2.6 Reactor Auxiliary Systems

The information in this section of the reference ABWR DCD, including all subsections, tables, and figures is incorporated by reference with the following departure to Figure 2.6.2.

Figure 2.6.2 Fuel Pool Cooling and Cleanup System

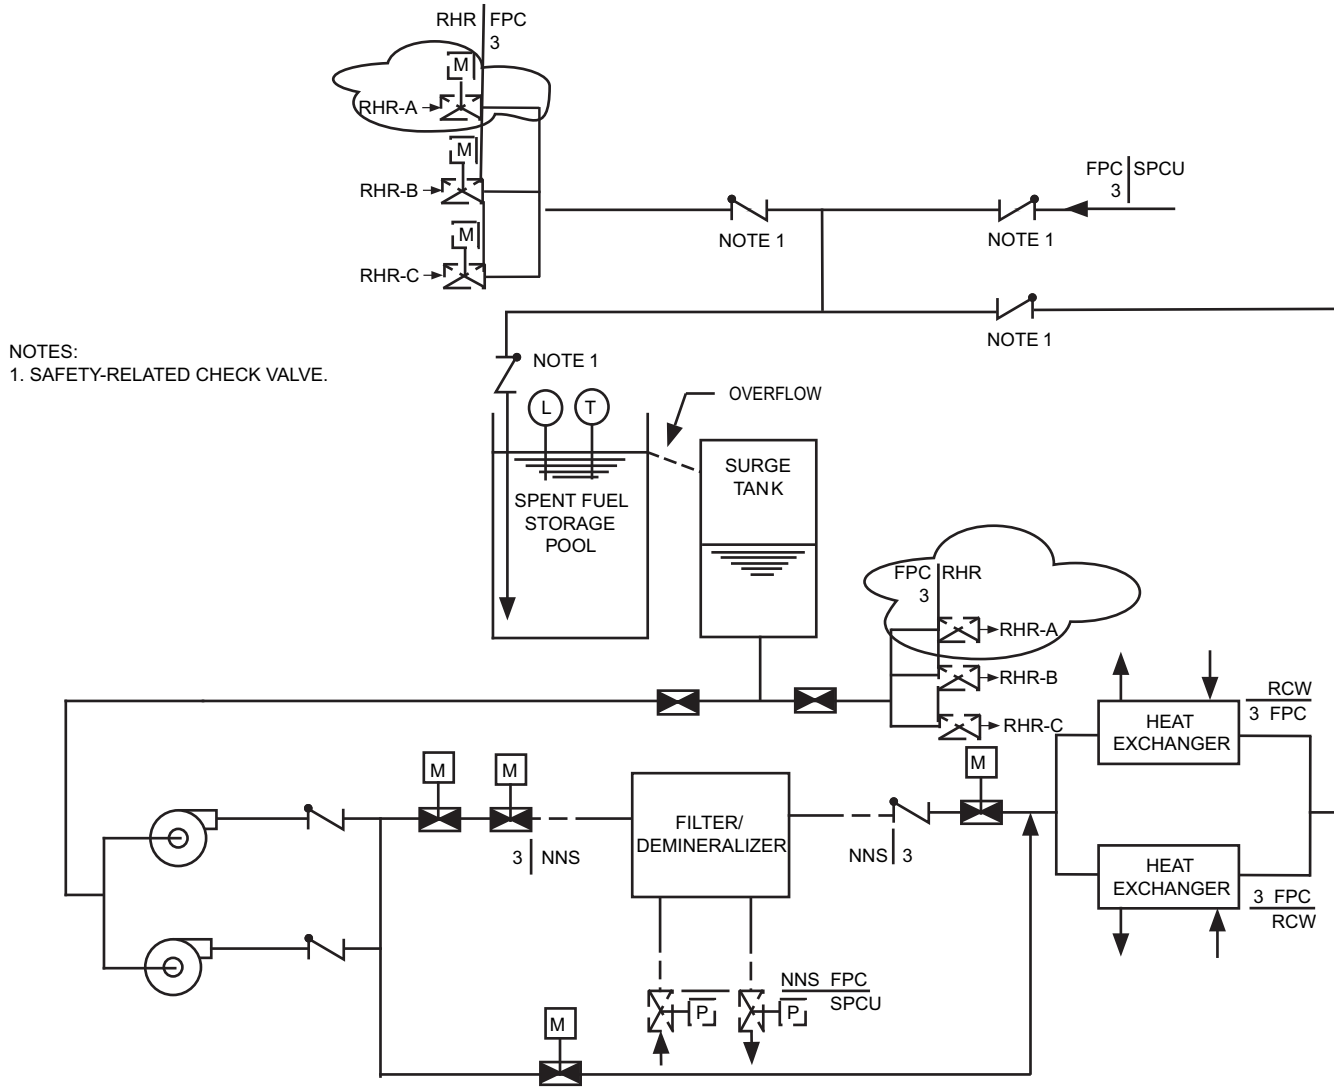
STD ~~T1-DEP~~ DEP T1 2.4-1
